**National
Fenestration
Rating Council,
Incorporated**

**NFRC 2001 and 2004 Technical
Interpretations**

Published:	March, 2005
Last Updated:	August, 2007
Applicable to 2001 and 2004 Procedures

TI-2003-16 09/08/03

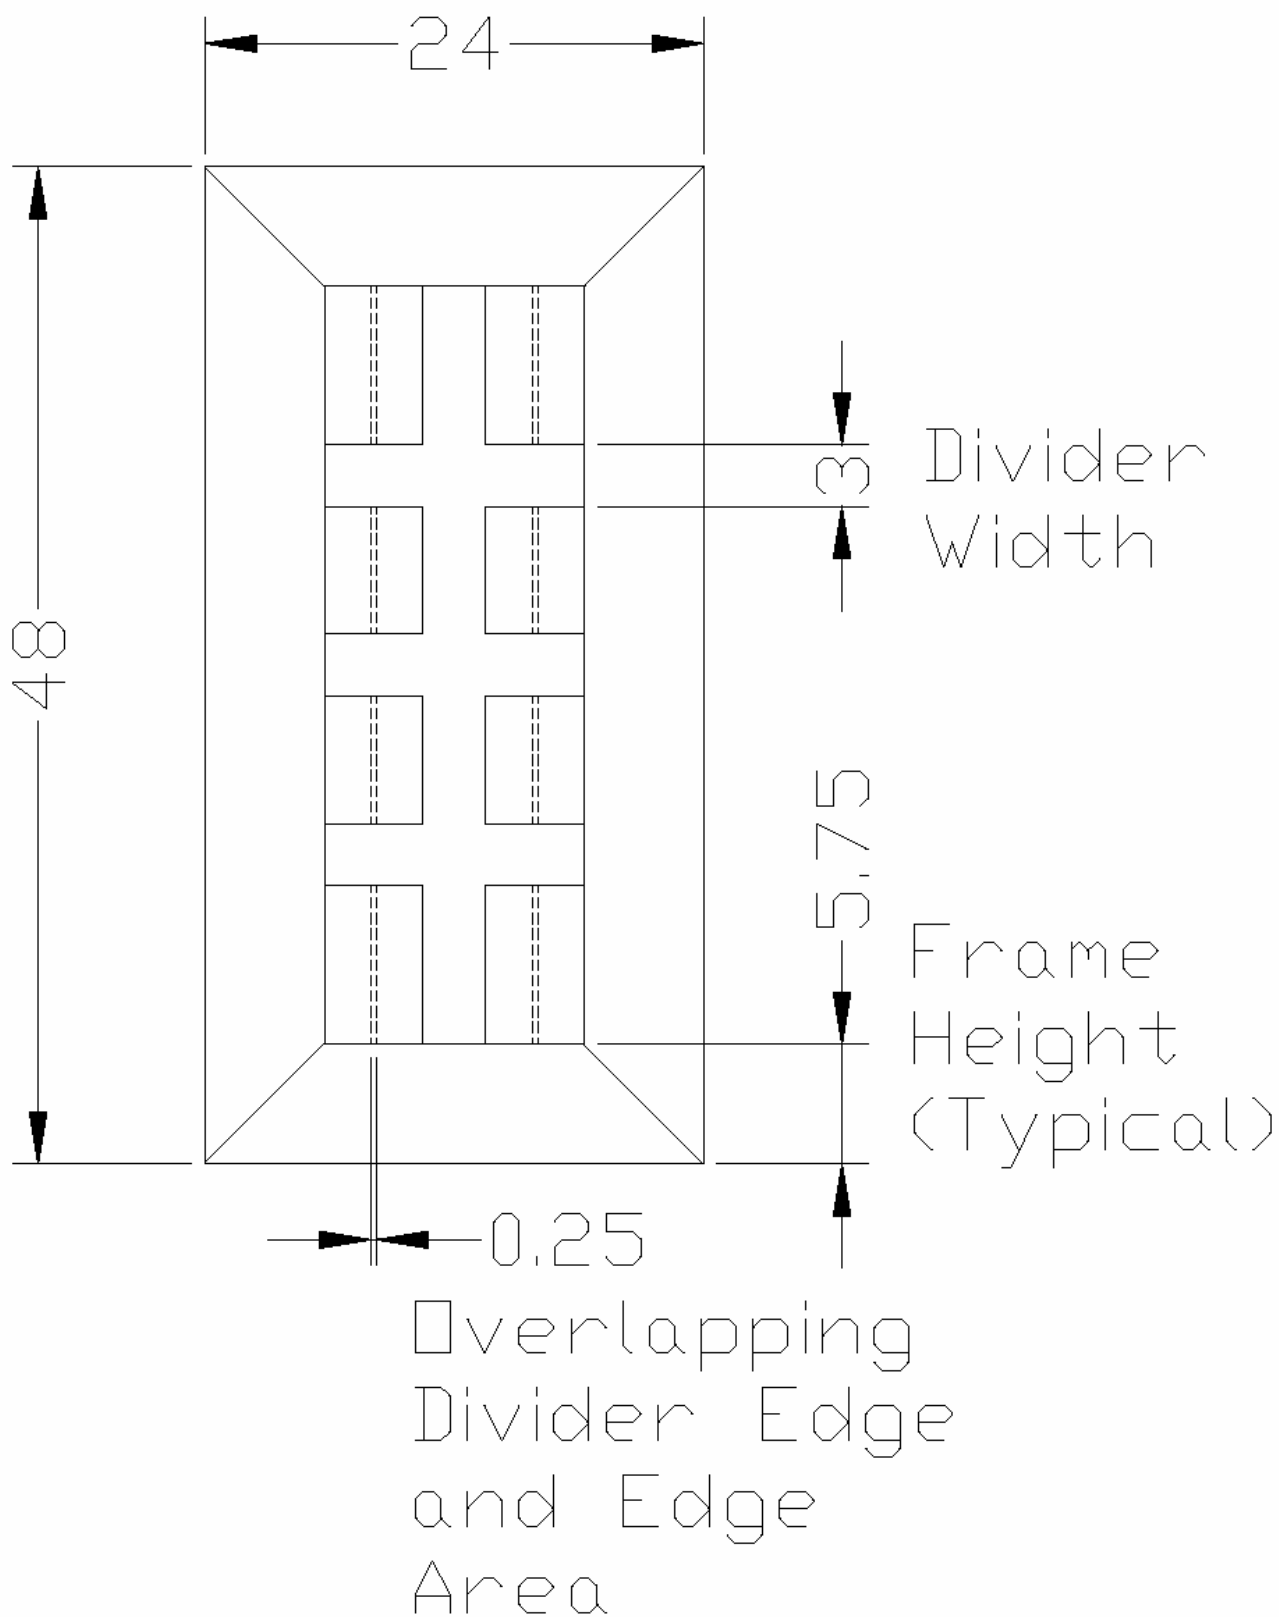
Interpretation Requested:
A standard window product is made with and without dividers. The dividers must be modeled in accordance with NFRC 100, but the default divider pattern does not allow for the full 63.5mm of edge-of-glass (divider) to be modeled. How should this product be area-weighted? (See attached drawing)

Interpretation :
<p>This interpretation shall apply to all fenestration products.</p> <p>Increase the overall dimension(s) by the distance of the overlap, thereby restoring the 63.5mm edge and divider-edge dimensions, leaving the center-of-glass area equal to zero.</p> <p><i>Note: This would be the same as the interpretation for transoms and sidelites (TI-100-99008)</i></p>

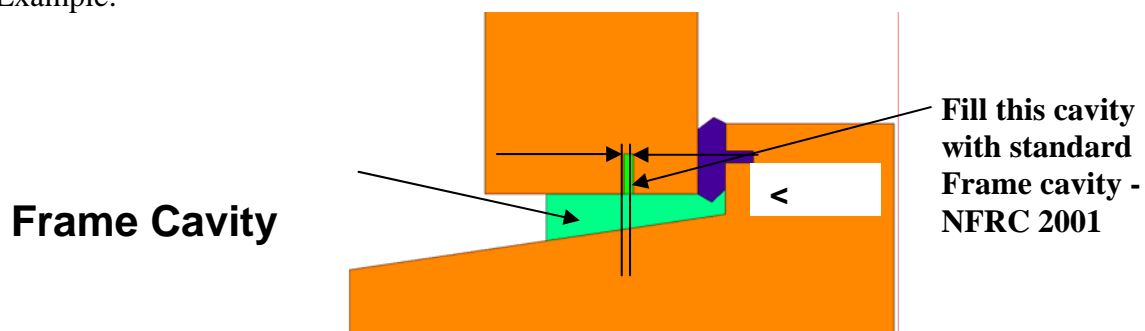
When defining exterior Slightly Ventilated Cavities, should cavities $\leq 2\text{mm}$ within the defined Slightly Ventilated Cavities be treated as standard Frame Cavities?

Yes. When an exterior cavity has been defined as a “Frame Cavity Slightly Ventilated NFRC 100-2001” per the simulation manual and now engulfs cavities that have openings less than or equal to 2mm, the cavities $\leq 2\text{mm}$ shall be filled with the standard “Frame Cavity NFRC 100-2001.”

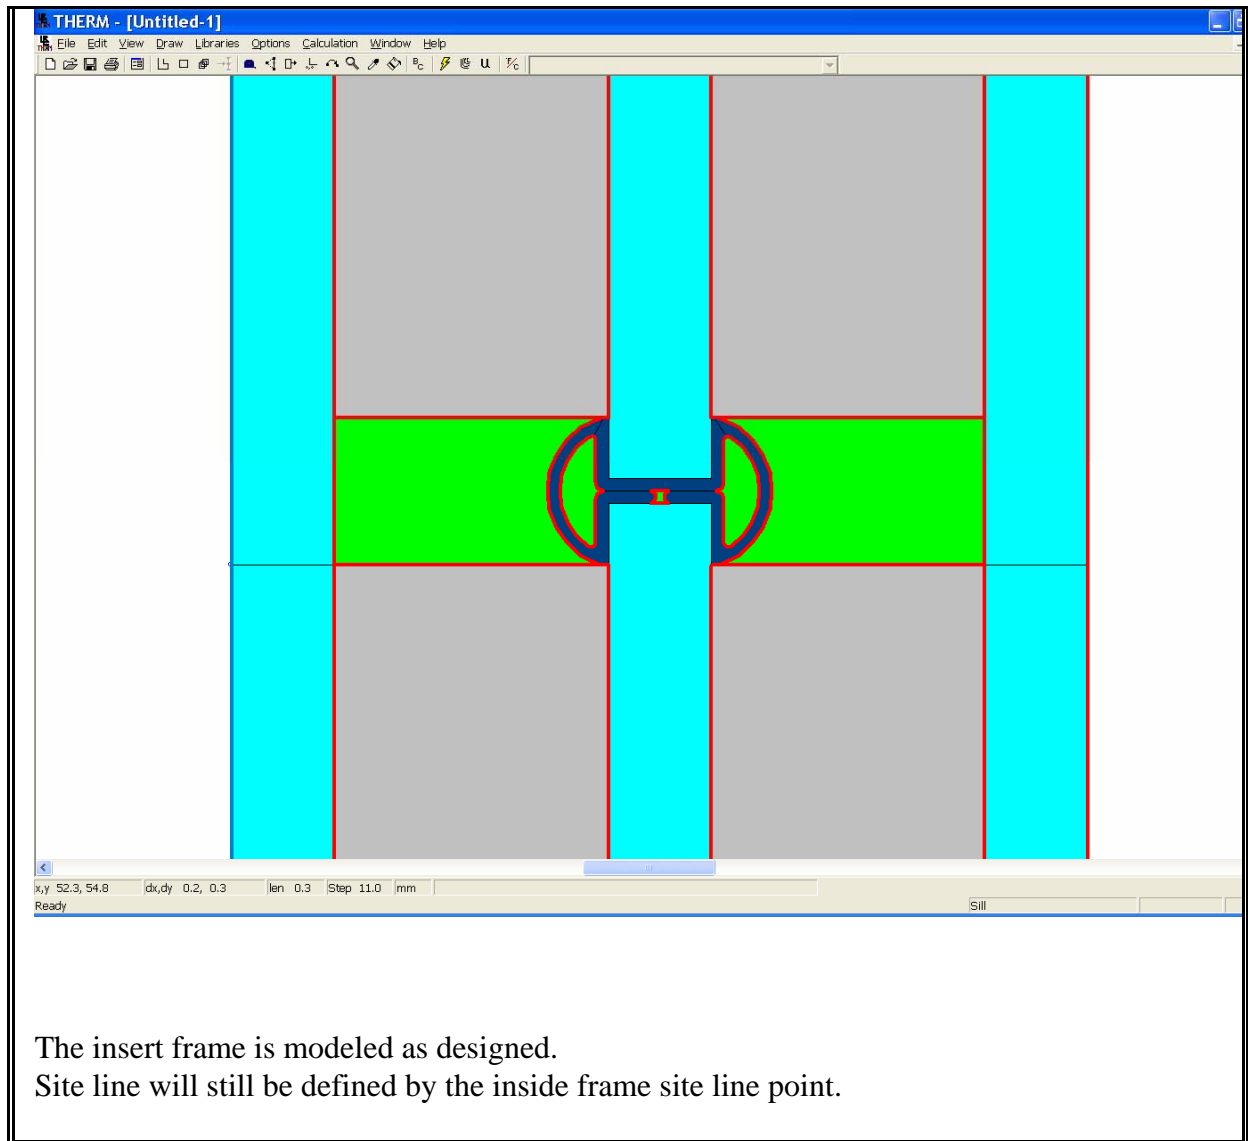
How is the IG unit with intermediate pane having lead divider and insert frame modeled? For U-factor and SHGC?

Camming shall be modeled in accordance with section 8.3.1 of NFRC simulation manual and as per steps defined below.

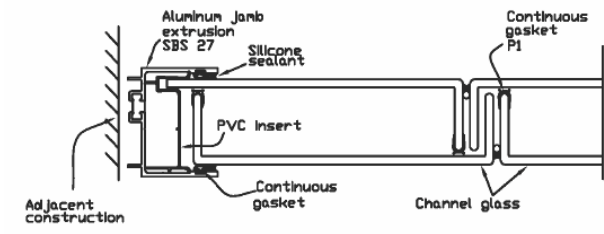
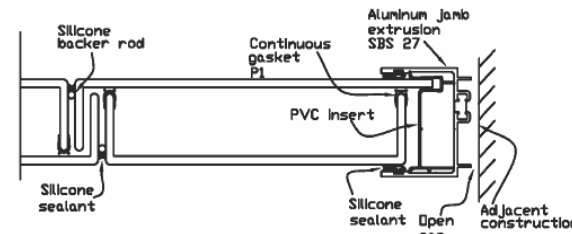
<p>Interpretation Requested:</p> <p>Please provide a general clarification of how a glazed wall system must be simulated when the system is applied as either a single or multiple story system.</p> <p>Also, answer the following clarifying questions:</p> <ol style="list-style-type: none"> 1. If a glazed wall system has intermediate horizontal members on a particular floor, does that mean that the product is automatically classified as a “curtain wall”? 2. Can a single-story system be classified as a “curtain wall”? 3. If there is a glazed wall system with a “head” and “sill” frame member on an individual floor, is this system considered a “window wall”?

<p>Interpretation:</p> <p>GENERAL CLARIFICATION</p> <p>A single story system shall be simulated as a window wall and a multi-story system shall be simulated as a curtain wall in accordance with Table 4-3 footnote #5.</p> <p style="margin-left: 40px;">⁵Two lites with one vertical mullion. Curtain walls shall be simulated and tested with intermediate verticals as jambs and intermediate horizontals as head/sill frame members. Window walls shall be simulated and tested with intermediate verticals as jambs and standard head and sill members. For rating of curtain walls and window walls, area weight intermediate members based on centerline dimensions. Glazed wall and sloped glazing shall be simulated and tested with standard jamb, head, and sill members (see Section 5.6).</p> <p>If a system is capable of being applied as either operator type, the system shall be simulated and rated as both operator types – a window wall and a curtain wall. Products modeled as both</p>

operator types shall be separate products lines and shall be permitted to be validated by either operator type.

Figure 1

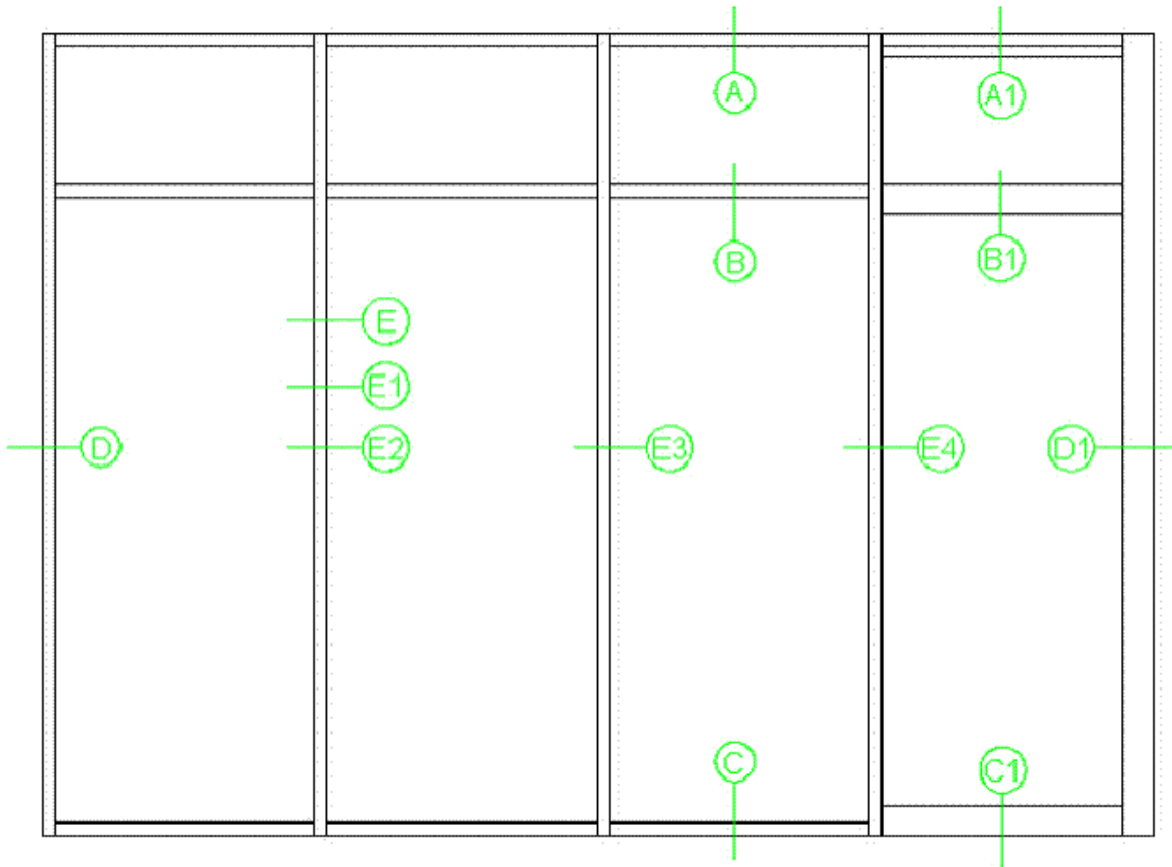
<i>Interpretation Requested:</i>
Please provide general clarification on modeling a store front system given in Figure 1 and how to select a typical cross section for modeling the intermediate verticals as jamb in a window wall system.

<i>Interpretation:</i>
The store front system shall be simulated as Window Walls system. As per footnote #5, Window walls shall be simulated and tested with intermediate verticals as jamb (using half of jamb for U-factor tag) and standard head and sill members. If the intermediate verticals are not the same, then they can either be simulated as different product lines, or grouped, if applicable. The horizontals in the storefront system, other than the door transom, shall be ignored. The door and transom, if present shall be each simulated separately. For door and transom use standard jamb definition (i.e., full U-factor tag).
